August 14, 2001

Refer to: HAS-10/B89

Mr. Bijan Kasraie	
Consolidated Tire Corporation	
1430 W. Peachtree St., NE Suite 705	
Atlanta, GA 30309	
TITLE:	PENDULUM TEST TIRE BLOCKOUT
SHEET:	1 OF 1
DRAWING NO:

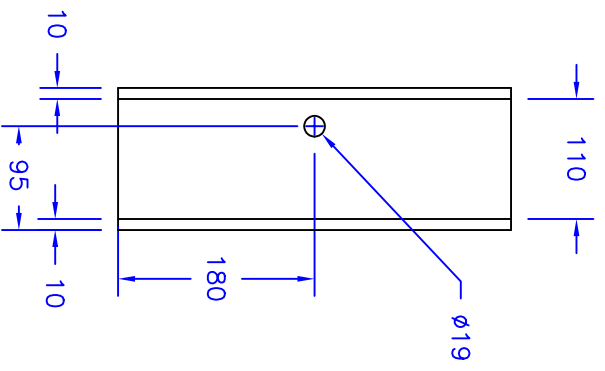
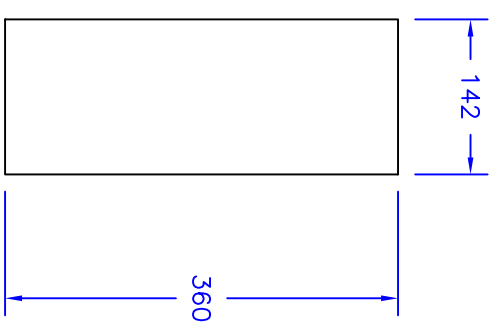
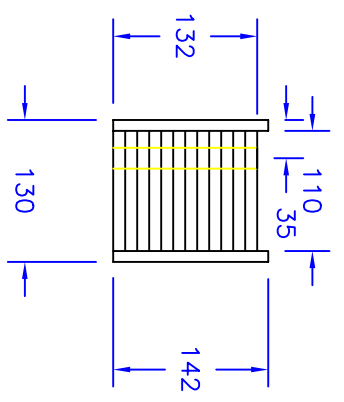
Mr. Richard Powers of my staff recently received Dr. Alberson's July 19 letter that included a revised drawing with a route incorporated into the design and with dimensions that conform more closely to previously tested and/or accepted blocks. Please note, however, that - without full scale testing - the minimum depth of the block must be 150 mm rather than the 132 mm shown in the enclosed drawing (Enclosure 1). A block 200-mm deep would also be acceptable and is likely to perform better in service.

Based on the results of the pendulum tests run, your product may be considered acceptable for use on the National Highway System (NHS) when it conforms to the dimensions shown on Enclosure 1 (as modified above) and is composed of the same materials as the tested blocks. As with all other recycled blocks accepted for use on the NHS, FHWA acceptance is based solely on the reported impact performance in the pendulum test and is not intended to address the long-term performance or durability of the product. Since your block is the first laminated design we have seen, the effects of weathering in particular should be carefully monitored on initial field installations.
